## Tract 5 Questions/Responses

**1322 – 1336 E 12<sup>th</sup> Street – On April 30, 2018, Matt Harriss, Chief Financial Officer, Butler Family Interests provided the following response:**

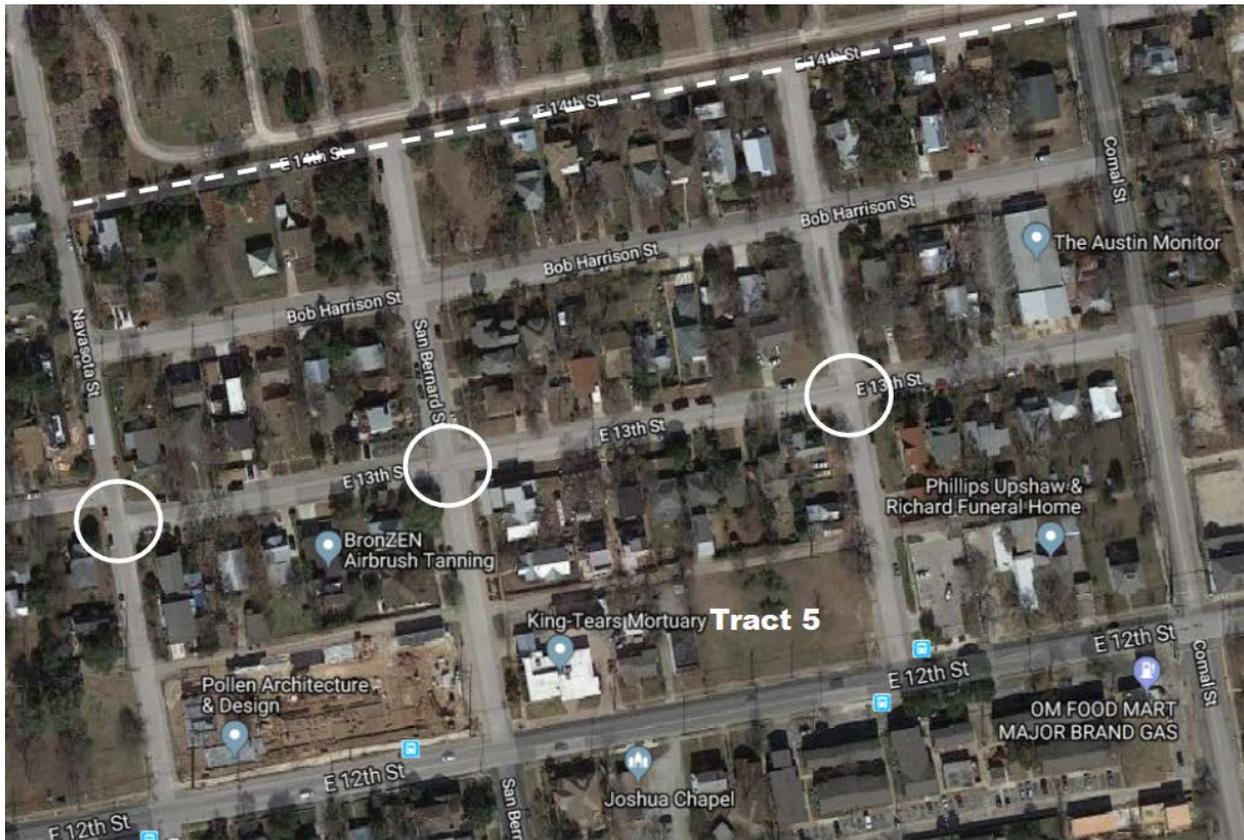
We request that Mr. James please help us quantify how permitted restaurant use(s) in some portion of the 8545 sf commercial space could impact the estimated trip count to and from the site.

How many daily trips per day does ITE, 10th edition, estimate for Quality Sit-Down Restaurant per 1000 sf? For Fast Food Restaurant/No Drive Through?

We would also appreciate any additional explanation of the calculation that Staff used to arrive at 186 trips for 8545 sf of space.
